CITY OF CARMEL-BY-THE-SEA CITY COUNCIL AGENDA

REGULAR MEETING Tuesday, August 3, 2021

4. Consideration of an Appeal by Christopher Mitchell (APP 21-197), on behalf of Esperanza Carmel Commercial LLC, of the Historic Resources Board decision to issue a Finding of Noncompliance with the Secretary of the Interior's Standards for the demolition of the Palo Alto Savings and Loan Bank Community Room located at Dolores 2 southeast of 7th Avenue, in the Service Commercial (SC) Zoning District

TO:	Historic Resources Board Commissioners
SUBMITTED BY:	Evan Kort, Associate Planner
SUBJECT:	Consideration of a Determination of Consistency for a Design Review Application (DR 20-395) for demolition of the Palo Alto Savings and Loan Community Room (Block: 91; Lot 6) and construction of a 16,898 square foot two story mixed-use development with a 11,371 square foot basement garage (Block 91; Lots 6, 8, & 10) in the Service Commercial (SC) Zoning District at Dolores 2 SE 7th; APN: 010-145-012.

HISTORIC BUILDING PROTECTION PLAN KEY NOTES

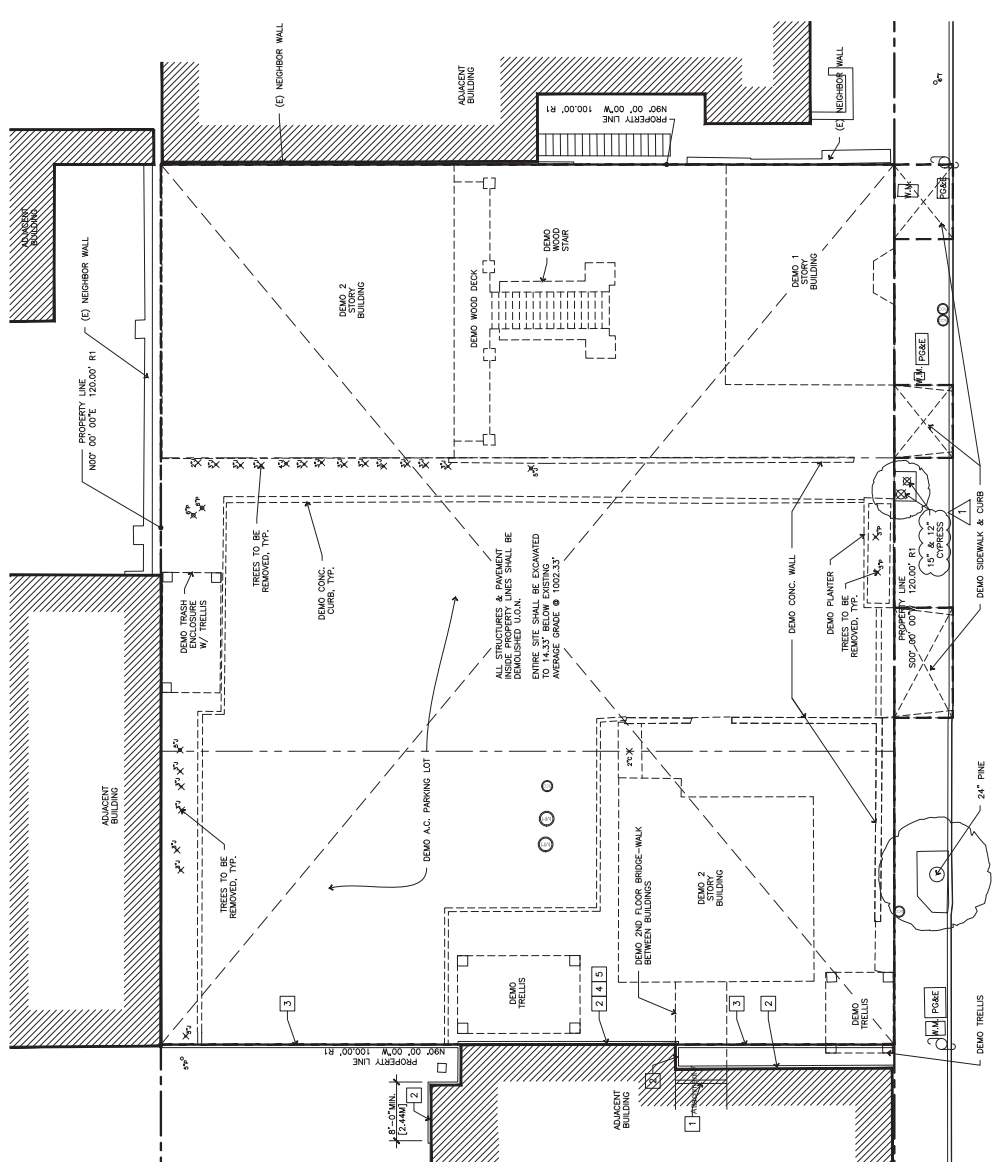
Staff Response: The applicant has submitted a written Protection and Monitoring Plan (Attachment 6) outlining the steps proposed to be taken to protect the adjacent bank building during the proposed demolition of the community room and during the proposed construction of the subject project. In addition to the written plan, the applicant has also provided a protection plan included in the preliminary project plans (Attachment 8, Sheet A1.1) that identify the proposed protection measures during construction, and are outlined in the "Historic Building Protection Plan Key Notes."

- CONSTRUCT BARRICADE WALL TO CLOSE OPENING TO BRIDGE-WALK INSIDE OF (E) BUILDING PRIOR TO ANY DEMOLITION WORK.
- REMOVE ALL EXISTING ANY SILENT TO WALL FOR RUST PROTECTION. ALSO IT SHALL SEAL DOORS, WINDOWS & OTHER OPENINGS PRIOR TO ANY DEMOLITION WORK.
- CONSTRUCT 8" HIGH SELF-SUPPORTING PLYWOOD BARRICADE WALL.
- REMOVE ALL EXISTING 1" OVERLAP 2" DESIGNATION FROM SHALL DESIGN AND 1" OVERLAP 2" DESIGNATION TO 1" BUILDING UNDERPINNING OF (E) BUILDING, FOOTING AS REQUIRED BY THE CONSTRUCTION OF BASEMENT GARAGE.

A1.0

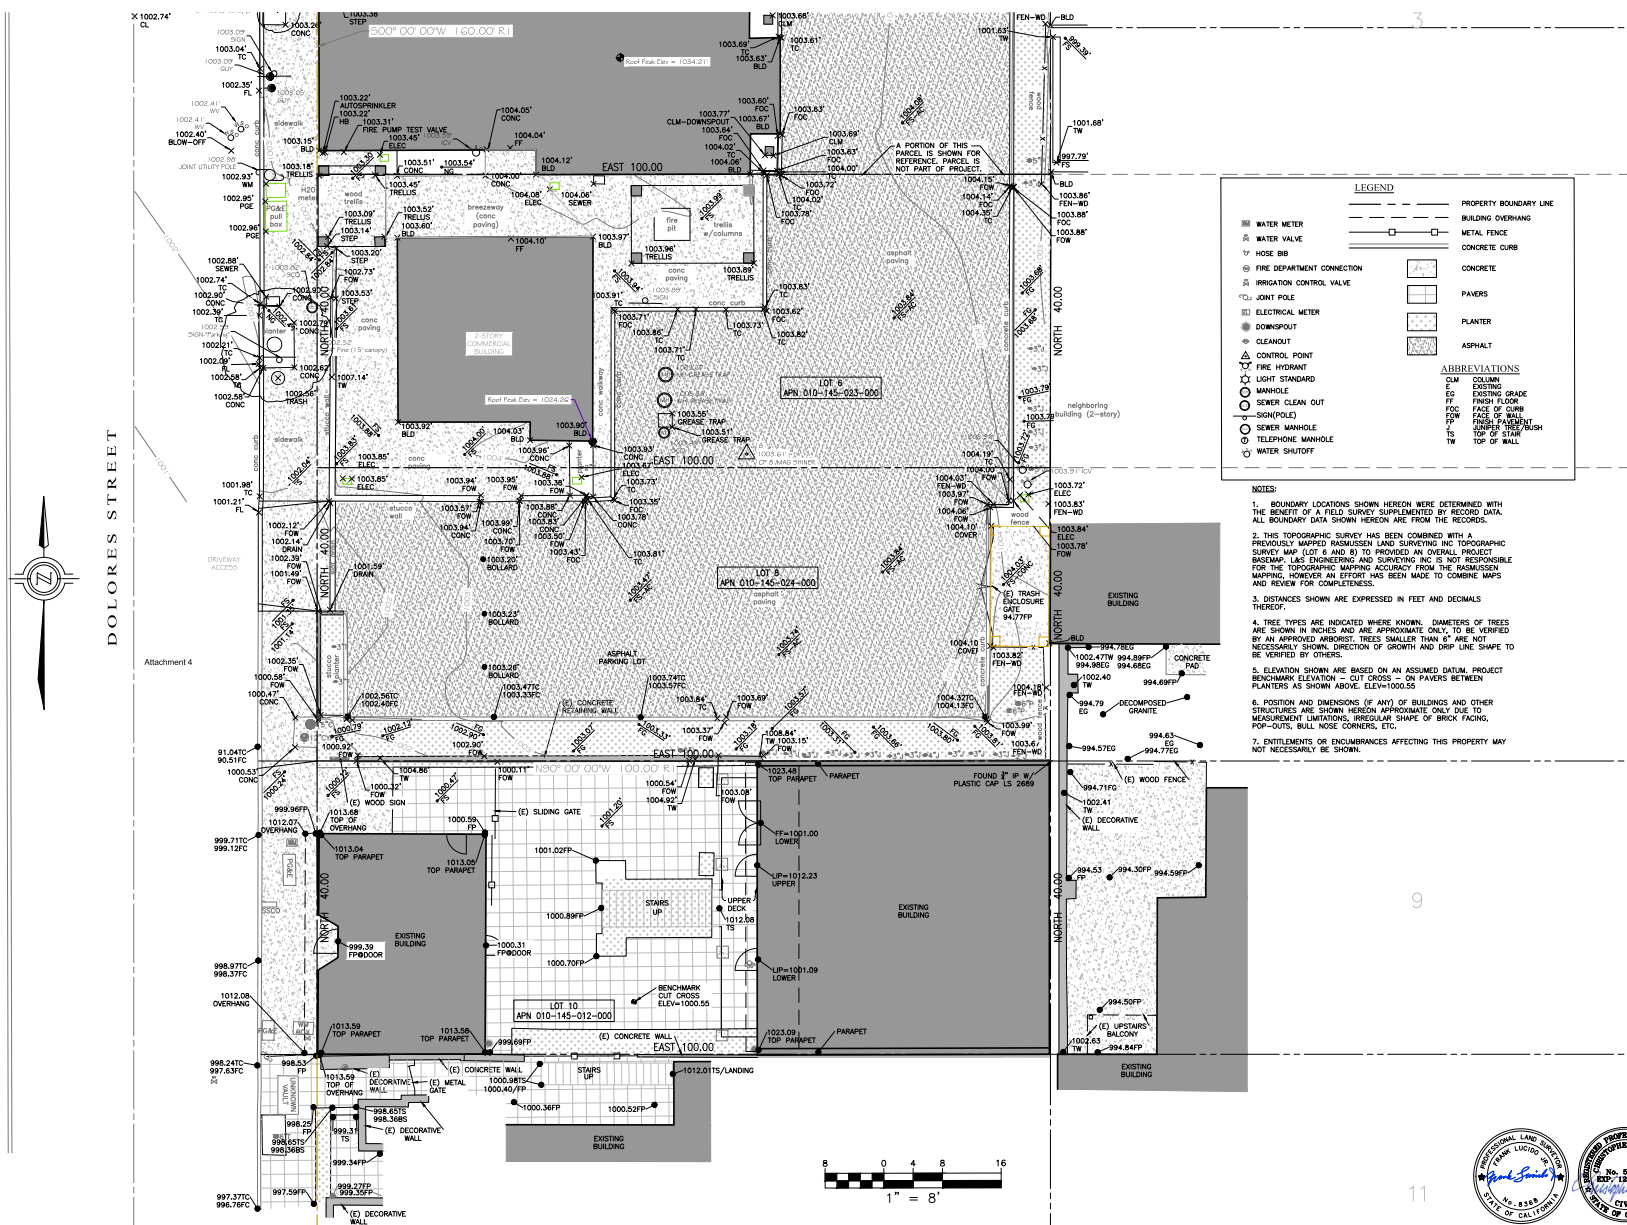
The existing separation between the bank building and community room is 8'4" at the nearest point, as dimensioned in the field by staff. As shown on the preliminary project plans (Attachment 8, Sheet A1.0), the proposed closest setback between the buildings is 7'. While Staff is supportive of allowing for some relief from the initially recommended setback line (northern building wall of the community room), Staff recommends the proposed building not be permitted to extend more than one foot beyond the existing northern wall of the community room.
